NUREG/CR-1697
ORNL/TM-439

Safety Review of the Design, Operation, and Radiation Sections of the General Electric Morris Operation Consolidated Safety Analysis Report

Prepared by J. P. McBride, K. H. Luk, C. R. Hammond

Oak Ridge National Laboratory

Fig. A.2. Numbering system for important structural members - crane support structure.

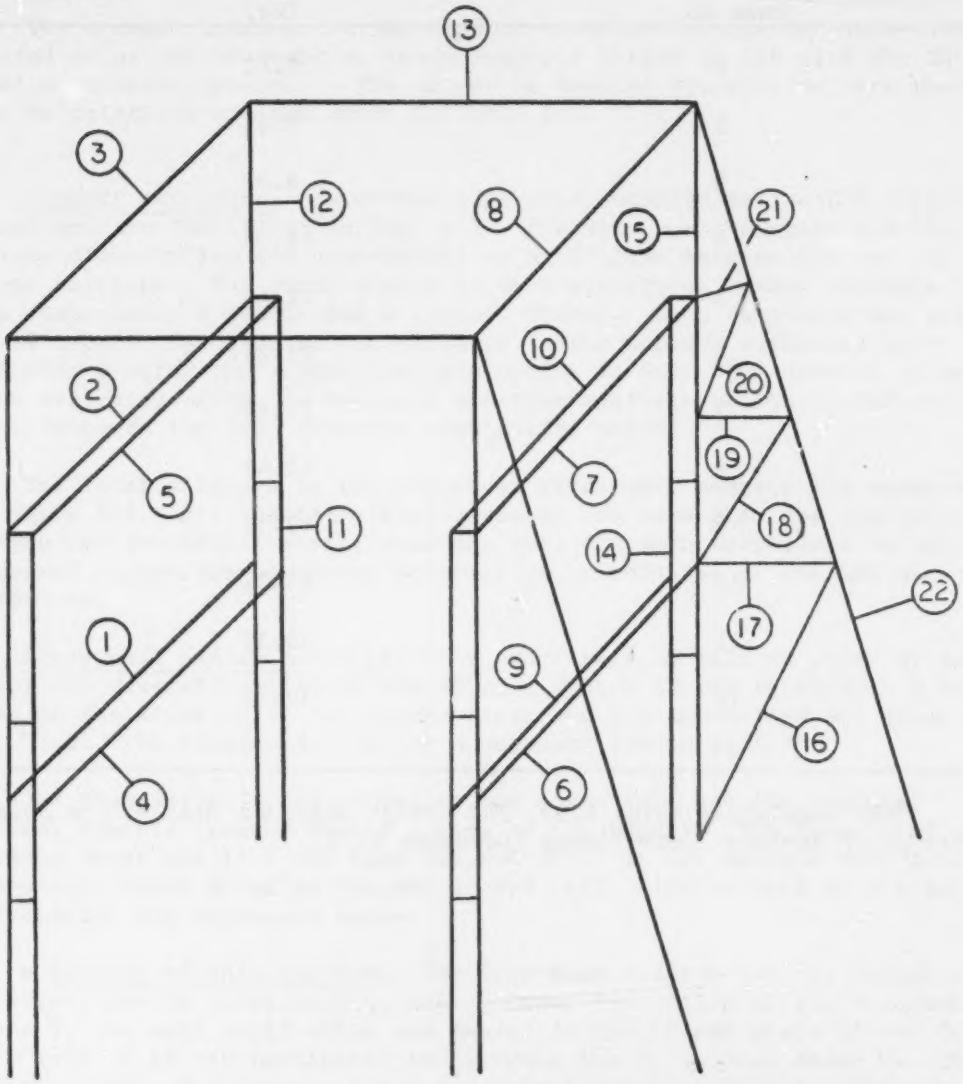
Support structure. Important structural members of the CHC support structure are identified in Fig. A.2. The structural members and the stress distribution are symmetrical to a midplane between the two "A" frame sections. The total stress in each structural member consists of two components; a static and a dynamic stress. Each component was computed separately. The static stresses in the support structure were calculated using the static analysis option in SAP. The dynamic stresses were evaluated using the response spectrum analysis option in SAP and in accordance to the NRC response combination method.[14]

The total stresses in the important structural members are summarized in Table A.2. All the calculated stresses are less than the nominal yield stress for structural steel, thus the safe shutdown earthquake is not expected to produce permanent deformation or collapse of the CHC support structure.

Fig. A.3. Crane rail and accessories.

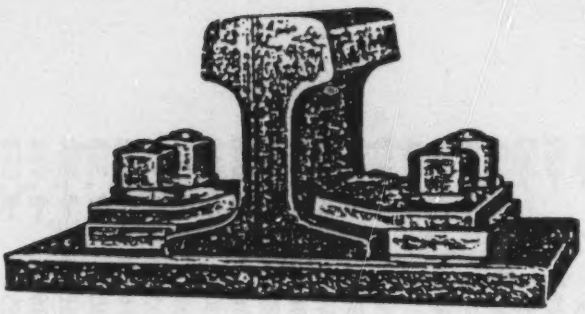
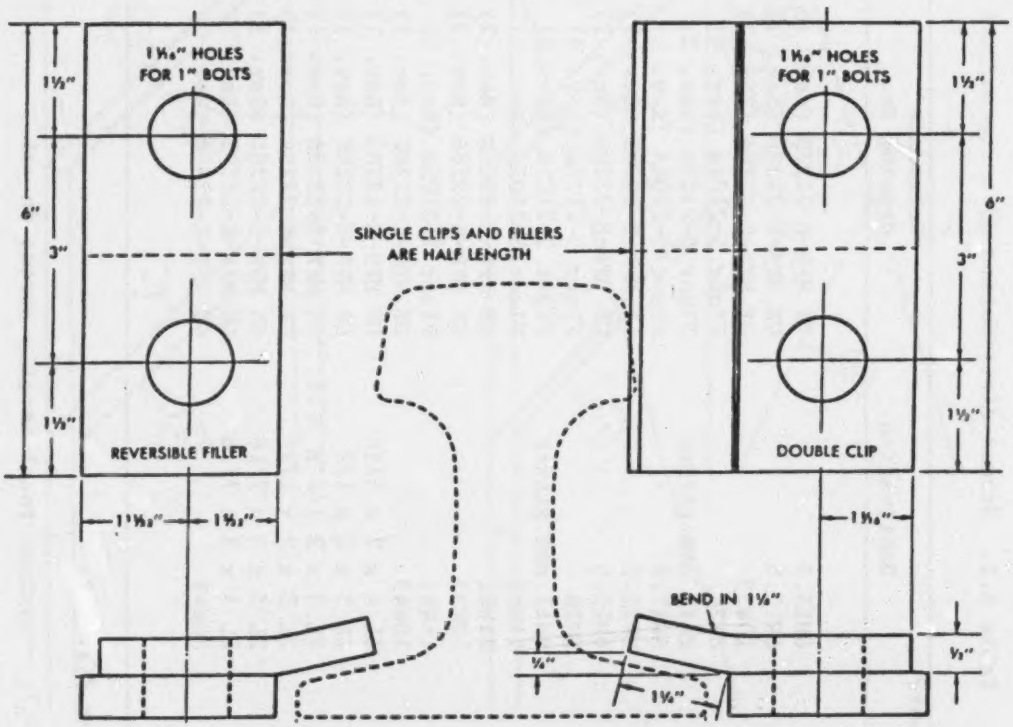
Crane rail and accessories. The crane rail is held in place by double clips and reversible fillers spaced at a 0.61-m (2-ft) interval. A section of the crane rail, its accessories, and key dimensions are shown in Fig. A.3. The section is that of a standard 135-lb rail.[12]

To evaluate the loading on the bolts, it was conservatively assumed that the force C acted on one double clip (Fig. A.3). The axial stress produced in the two 1-in. bolts is approximately 6300 psi. This estimated bolt tensile stress is much smaller than the normal yield stress for a 1-in. carbon steel bolt.

Fig. A.4. Free-body diagram for rail sliding case.

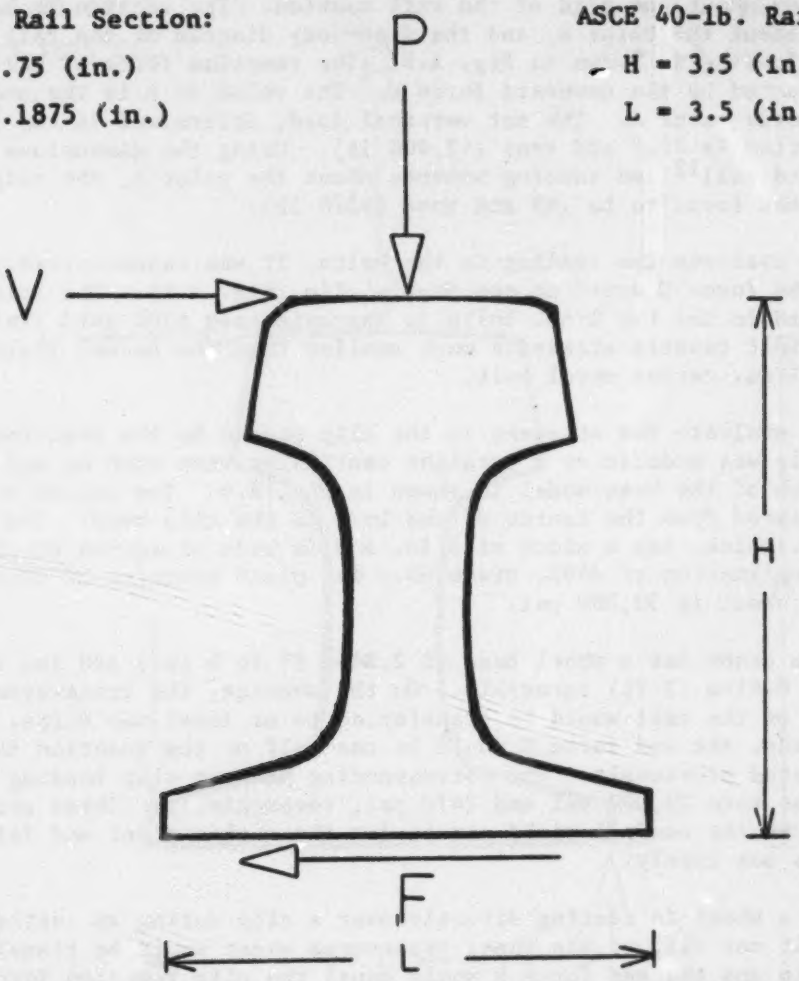
- Sliding of Rail Section. The free-body diagram for the forces under consideration is shown in Fig. A.4. Under the action of the transverse shear V, the rail could slide and impact in the filler plate if the friction force F is not sufficient to overcome the transverse shear V. The friction force F is proportional to the net vertical load P. The net vertical load P is the static wheel loading (one-fourth of the total weight) less the maximum vertical shear produced by the seismic motion. For the CHC, the static wheel loading is 29.6 std tons (59,200 lb). The calculated maximum shear is 8.2 std tons (16,400 lb) and the corresponding net vertical load P is 21.4 std tons (42,800 lb). The static friction coefficient between dry steel surfaces is approximately 0.7 (ref. 15) and the maximum friction force that can be developed between the rail and the

girder is 15.0 std tons (30,000 lb). Therefore, the friction force can balance the maximum transverse shear of 14.2 std tons (28,400 lb) and slipping of the rail is not anticipated.

Sliding of rail sections. Due to its ground level elevation, dynamic amplification was assumed to be negligible for the SBC. The free-body diagram under consideration is shown in Fig. A.4. The transverse shear V was taken to be 20% of the total weight (i.e., 0.2 x g lateral acceleration), equally divided, or 2150 lb per wheel. The corresponding vertical shear is 1075 lb. The net vertical force at each wheel, P, namely, one-fourth of total weight minus the vertical shear, is 9680 lb. Using a static coefficient of 0.7 (ref. 15), the maximum friction force that can be developed between the rail and the steel support plate is 6770 lb. The friction force F is significantly larger than the transverse force V and slipping of the crane rail on the support plate is not expected.

Fig. A.5. Free-body diagram for clip reaction force.

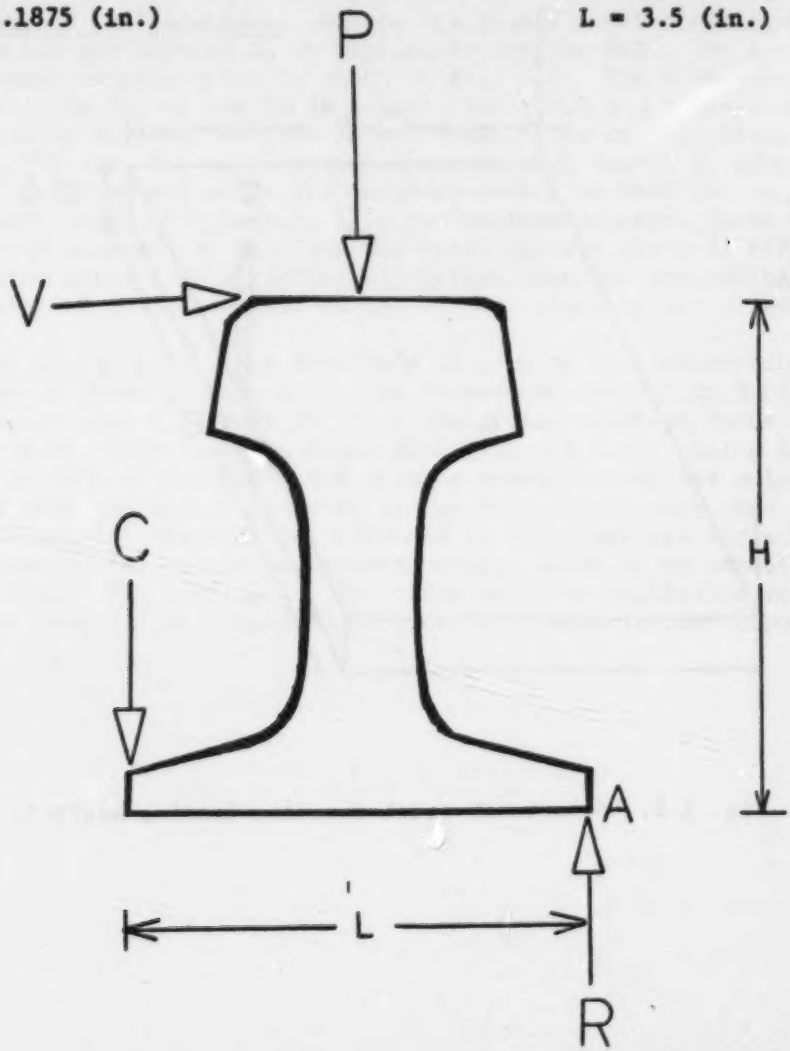
• Forces on the Clip. The transverse force V might cause an impending rotation about one edge of the rail section. The section is assumed to pivot about the Point A, and the free-body diagram of the rail section under loading is shown in Fig. A.5. The reaction force of the slip is represented by the downward force C. The value of R is the ground reaction force point A. The net vertical load, determined in the previous subsection is 21.5 std tons (42,900 lb). Using the dimensions of a standard rail[12] and summing moments about the point A, the clip reaction force was found to be .49 std tons (9870 lb).

Forces on the clip. The free body diagram of the forces under consideration is shown in Fig. A.5. The transverse shear V is 2150 lb. The net vertical force P is 9680 lb, R is the ground reaction force at point A, and C is the clip reaction force acting on the rail. Using the dimensions of an ASCE 40-lb rail[12] and summing moments about the point A, it was found that the moment produced by the force P was more than sufficient to counter balance that produced by the trnsverse force V. The rail section cannot rotate and, consequently, there is no reaction force from the clip. The loadings on the clips would be negligible and the transverse shear is not expected to cause a failure in the clips of the SBC.

Fig. A.6. Structural model for clip bending analysis.

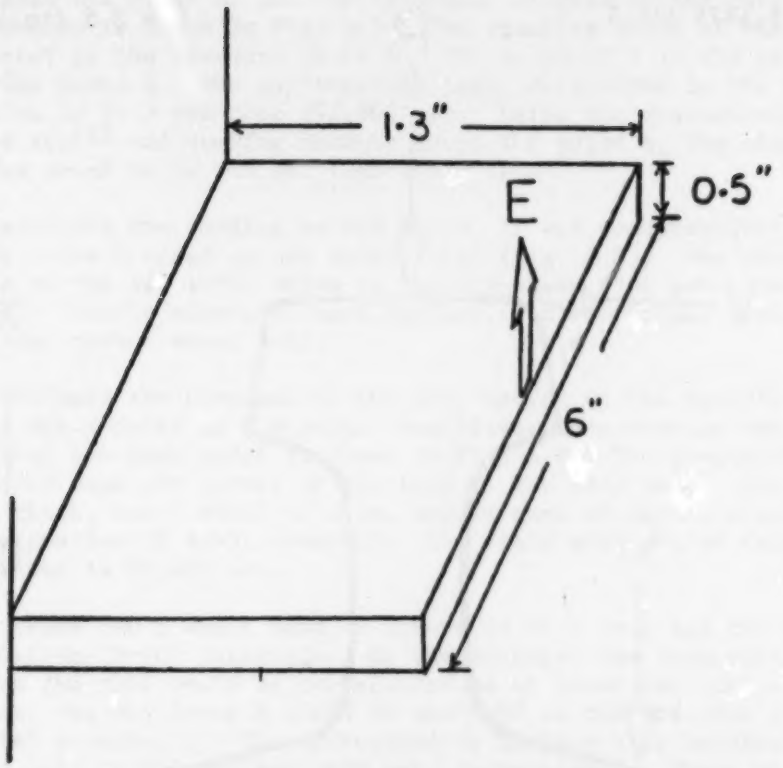
To evaluate the stresses in the clip caused by the reaction force C, the clip was modeled as a straight cantilever beam with an end force E. A sketch of the beam model is shown in Fig. A.6. The length of 1.3 in. is measured from the center of the bolt to the clip bend. The clip is 0.5 in. thick, has a width of 6 in. and is made of carbon steel with an ASTM designation of A663, Grade 60. The yield strength of that grade of carbon steel is 30,000 psi.

The crane has a wheel base of 2.84-m (9 ft 4 in.) and the rail clips are on 0.61-m (2-ft) intervals. On the average, the transverse shear acting on the rail would be transferred to at least two clips. In the two clip case, the end force E would be one-half of the reaction force C as calculated previously. The corresponding maximum clip bending and shear stresses were 23,000 psi and 2470 psi, respectively. These stresses are less than the nominal yield stress for the carbon steel and failure of the clip is not likely.

If a wheel is resting directly over a clip during an earthquake, most, if not all, of the wheel transverse shear would be transferred to one clip and the end force E would equal the clip reaction force C. For this case, the maximum clip bending stress would exceed yield and the clip could become a plastic hinge. As soon as one clip began to yield, the transverse load would be transferred to the two adjacent clips. Results from the previous discussion indicated that two clips can absorb the maximum transverse shear without yielding. Therefore, it is conceivable that the transverse shear produced by seismic motions could cause yielding in one clip but the adjacent clips would provide more than adequate compensation for such a failure.
